**U.S. NUCLEAR REGULATORY COMMISSION SAFETY
EVALUATION REPORT FOR THE HIGH ASSAY LOW
ENRICHED URANIUM DEMONSTRATION PROGRAM
AT CENTRUS ENERGY CORP./AMERICAN
CENTRIFUGE OPERATING, LLC's AMERICAN
CENTRIFUGE PLANT IN PIKETON, OHIO**

DOCKET NUMBER 70-7004

LICENSE NUMBER SNM-2011

June 2021

Figure 1 – Critical masses of homogeneous water-moderated U(93.2) spheres. (LA-10860-MS)

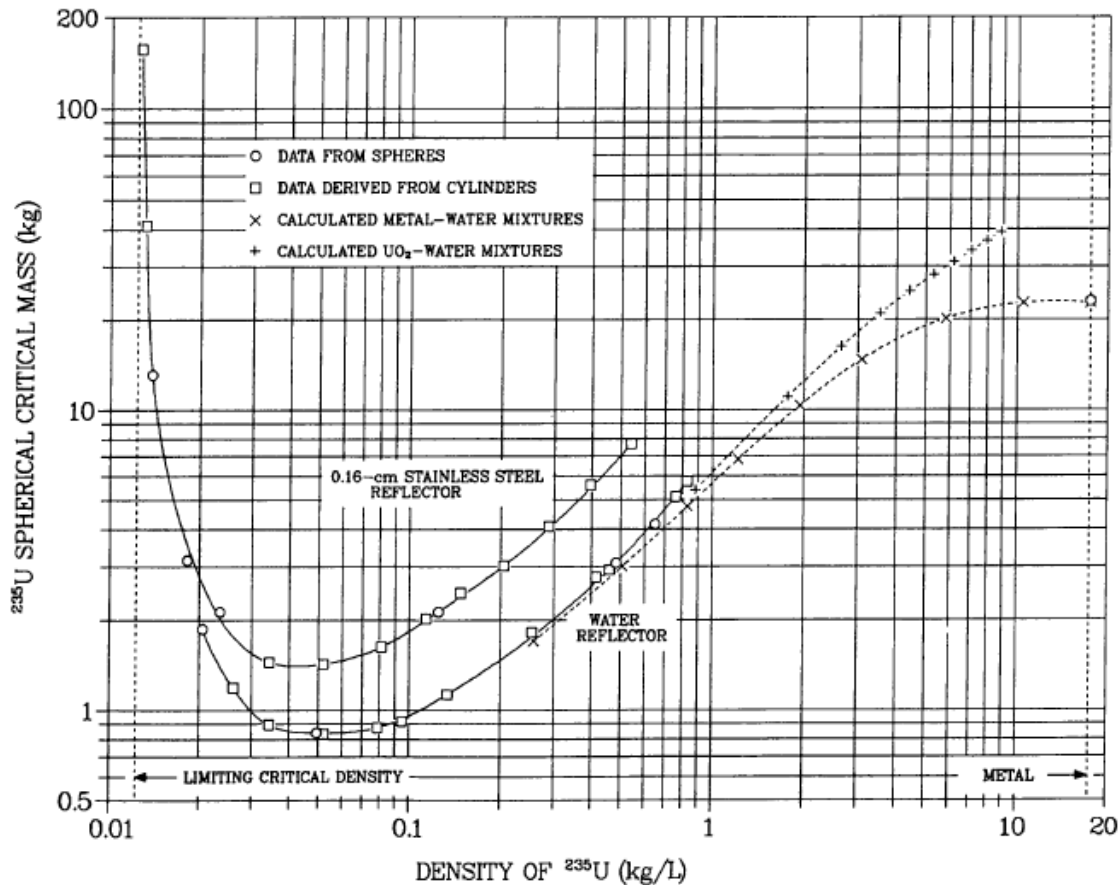
Based on a review of LA-10860-MS critical mass plots (Figure 1), the staff determined that the minimum critical mass for U-235 is approximately 764 grams. This value represents the absolute minimum mass required for criticality under the worst-case conditions for each NCS parameter (93.2 wt.% enrichment, spherical geometry, U-metal composition, optimum interstitial moderation, full light-water reflection, etc.). The staff also reviewed ANSI/ANS-8.1, which identified a minimum critical mass of approximately 760 grams for uranyl fluoride solutions. Given that these values represent the absolute minimum critical mass and that the normal and credible abnormal conditions associated with ACO operations are far less reactive (e.g., under-moderated ≤ 25 wt.% enrichment), the staff determined that the factor of 7 stated in the proposed change is technically conservative and consistent with reputable technical references and NRC-endorsed standards (ANSI/ANS-8.1), and is, therefore, acceptable.

Figure 2: Estimated prompt dose for 93.2 wt.% uranyl nitrate (left) and 4.95 wt.% uranyl fluoride (right) 10¹⁷ fissions.

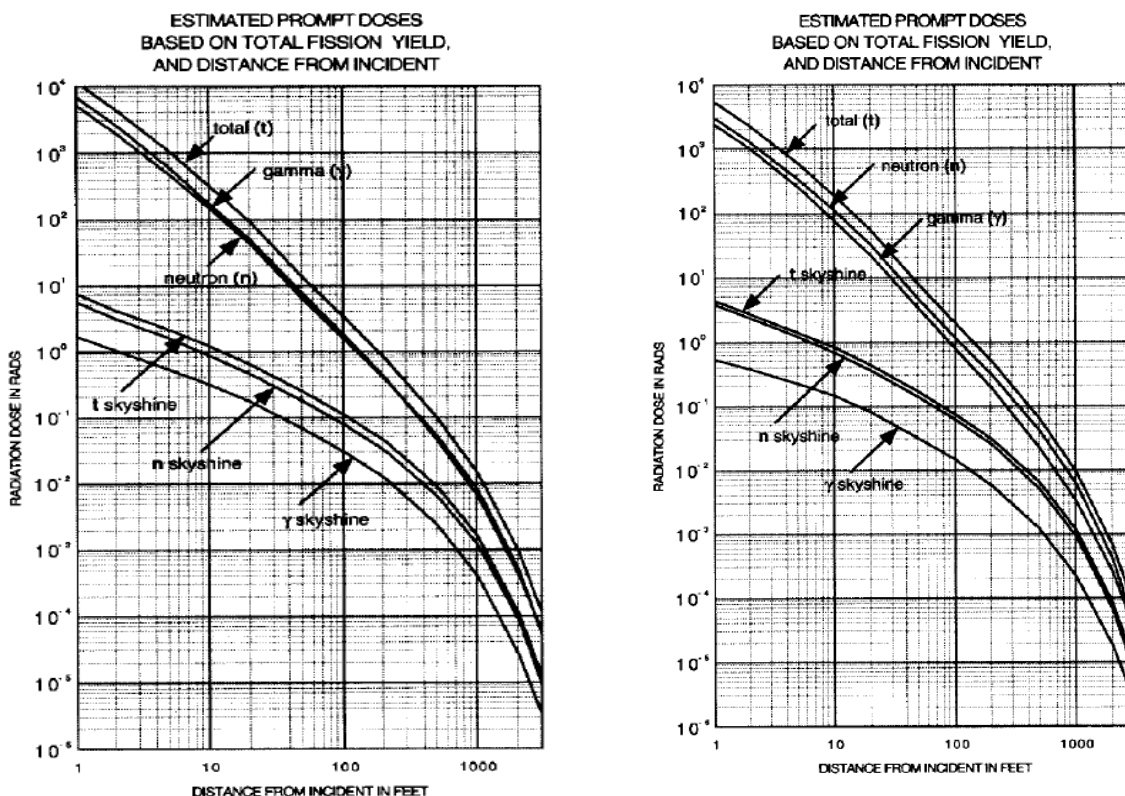
From review of Figure 2, as shown in Table 1, the staff noted that the dose from a system representative of ACO's operations (20 wt.% UF₆ or uranyl fluoride) would be somewhere between 0.5 and 0.4 rad at a distance of 125 feet. The values derived from NUREG/CR-6504 provide reasonable support to conclude that the dose at 125 feet (0.5 rad which is at most 10 rem¹) would be far less than the 100 rem and 25 rem total effective dose equivalent to the
